Site Instruction

Project Name: AQUAVISTA - Bayside
Client: TRIDEL Corporation
To: TRIDEL Corporation
Attention: Chadi Loza
Fax number: -

Project No.: 8489D
ADD No.: E 001
Page No.: 1 of 1+ 1 Attached
Office: Toronto
From: Sunanda Perera
Tao Li

Title: Electrical Room P218 Partitioning

11 PARKS ELECTRICAL ROOM - LEVEL P2
1: 50

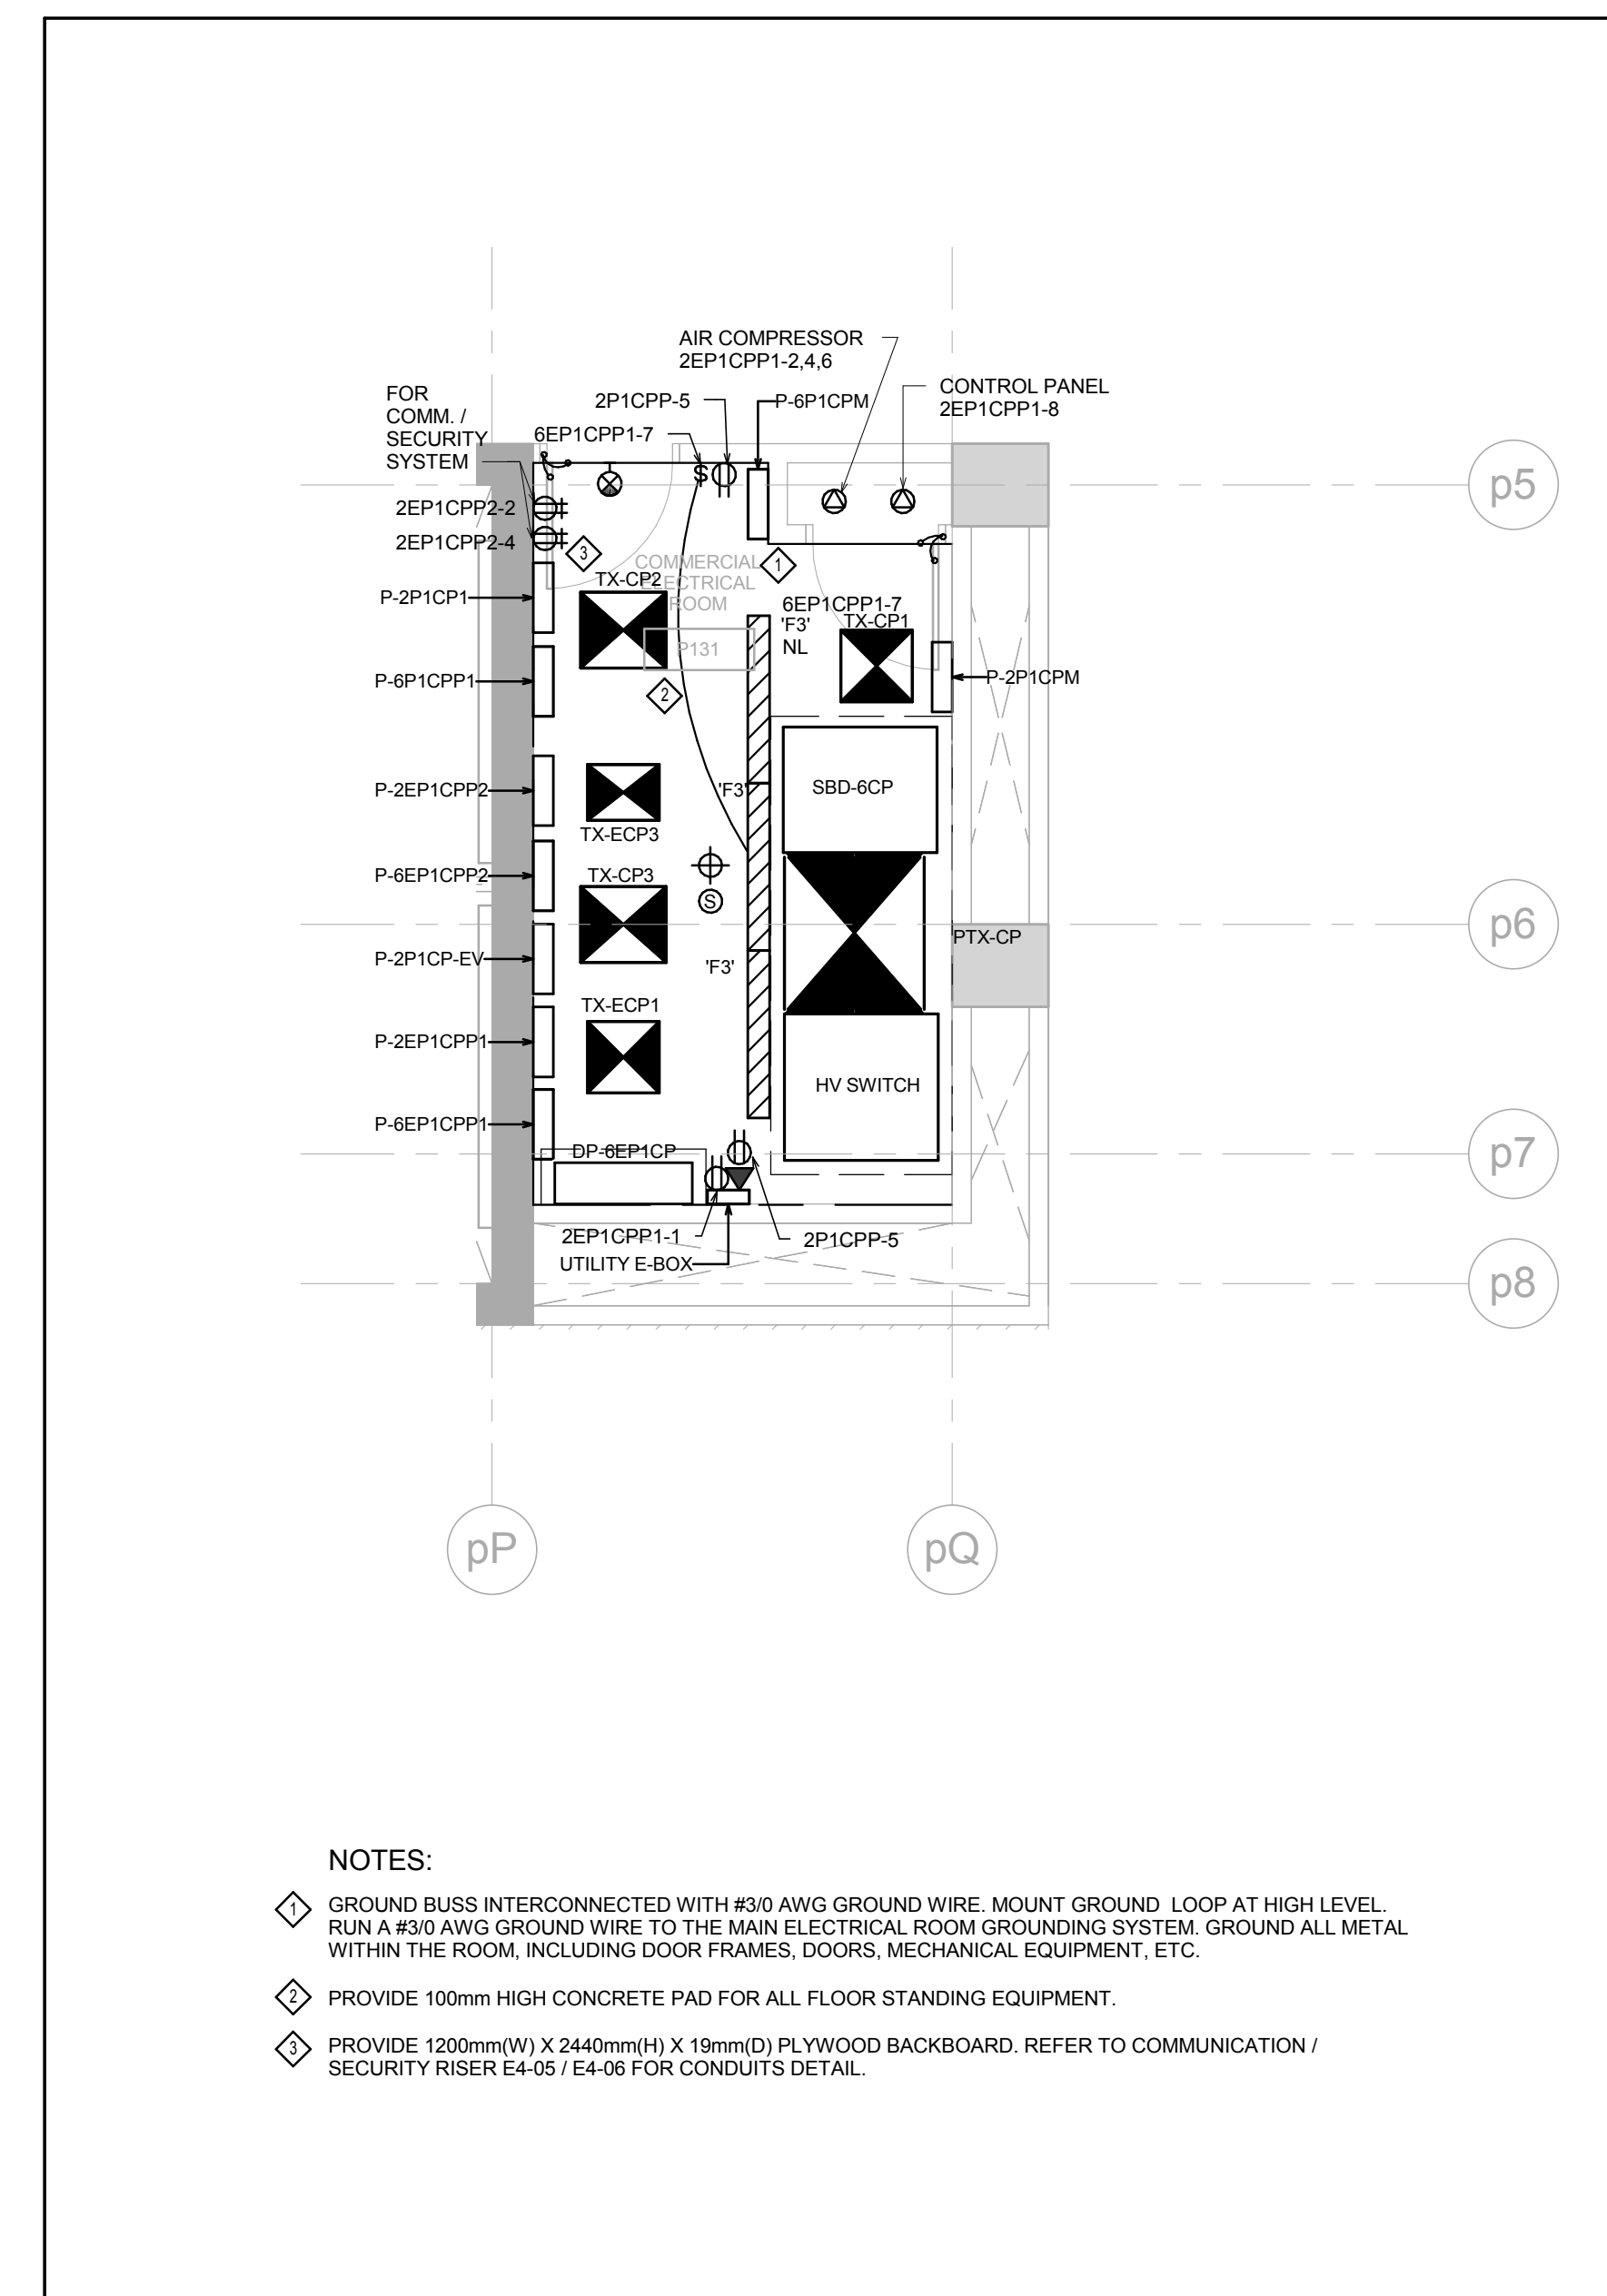
Drawing No.	Drawing Issued	Items
E5-01	YES	<ul style="list-style-type: none"> Revised layout for electrical room P218. Add one type 'F3' fixture as shown.
